Refer to: HSA-10/SS-109

Thank you for your submittal of May 8, 2002 and your letter of July 9, 2002, requesting Federal Highway Administration (FHWA) acceptance of your company's swing-away mailbox support and delineators as breakaway systems for use on the National Highway System (NHS). Accompanying your letter was a report from Texas Transportation Institute and videos of the mailbox crash tests. You requested that we find the Swing-A-Way Mailbox and the swinging delineator designs acceptable for use on the NHS under the provisions of National Cooperative Highway Research Program (NCHRP) Report 350 "Recommended Procedures for the Safety Performance Evaluation of Highway Features."

Figure 1. Schematic of Roadside Safety Devices Swing-Away Mailbox Support Design.

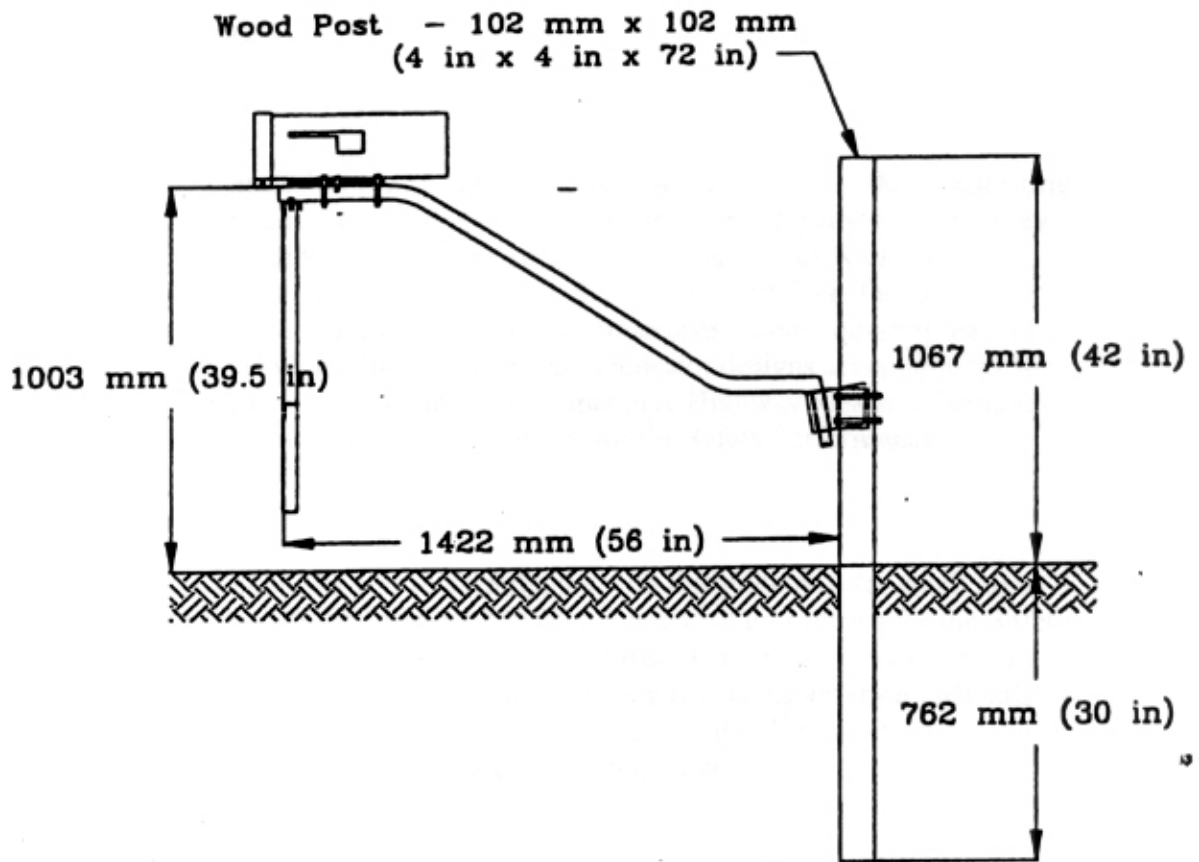
Damage to the test vehicle resulting from the mailbox tests was limited to dents in the bumper and hood, with scraped paint on the side. There was no windshield contact during either test. Velocity changes were all within acceptable limits, and the only stub remaining consisted of wood splinters. The results of testing met the FHWA requirements and, therefore, the devices described above and shown in the enclosed drawings for reference are acceptable for use as Test Level 3 devices on the NHS under the range of conditions tested, when proposed by a State.
